**Government of Pakistan
Revenue Division
Federal Board of Revenue
(Pakistan Raises Revenue Program Office)**

Re. No. 3(8)/2026-Addl-Dir(P&F) / 565387

Subject: MINUTES OF PRE-BID MEETING AND RESPONSES TO THE CLARIFICATION - PROCUREMENT AND INSTALLATION OF GENERATORS FOR DIGITAL ENFORCEMENT STATIONS (DES) AT INDUS SITES, PHASE-I (10 DES SITES)

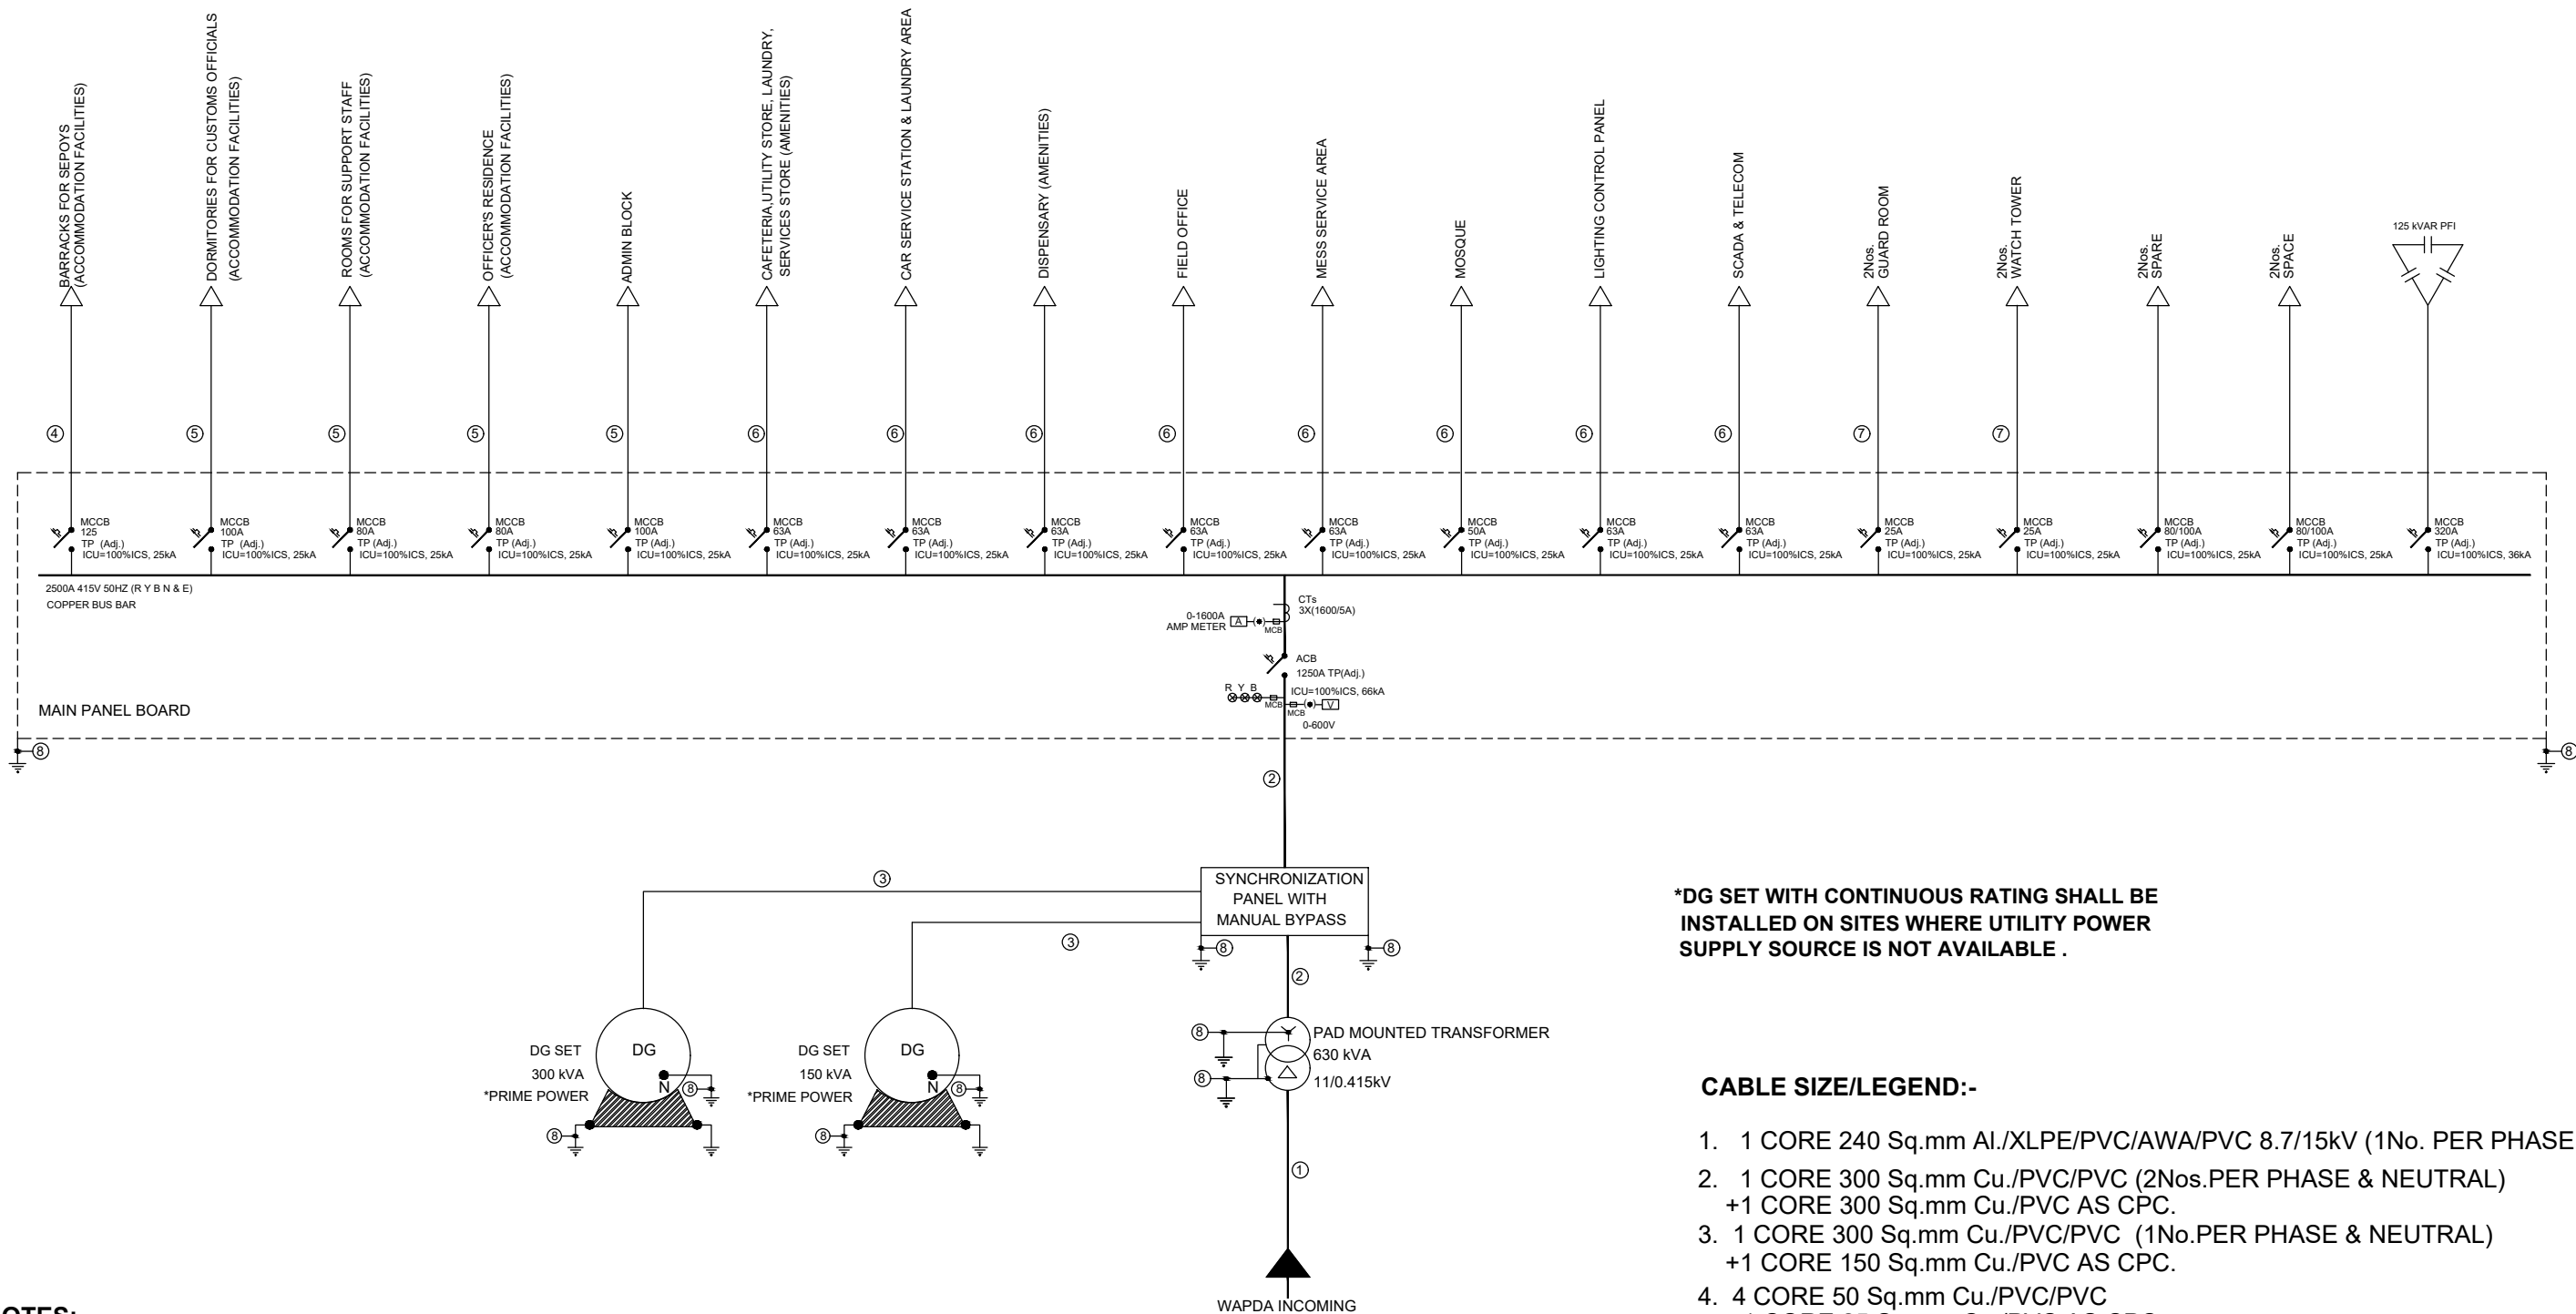
5.	Section IV (Bidding forms) – Site wise BOQ Price Schedule	Please confirm the requirements of 1-core power cables as mentioned in tender documents whereas 4-core cables are normally used for 3-phase generators.	For separate earthing of the Genset. SLD attached at Annex-1 .

8.	Section VII (Schedule of Requirements) – Technical Specifications	Synchronization Panel SLD Please share the Single Line Diagram (SLD) of the synchronization panel for our technical review.	Clearly mentioned in RFP Panel drawings (submittal) is the responsibility of the bidder with complete scope of work scheme given, however simple SLD is attached at Annex-1
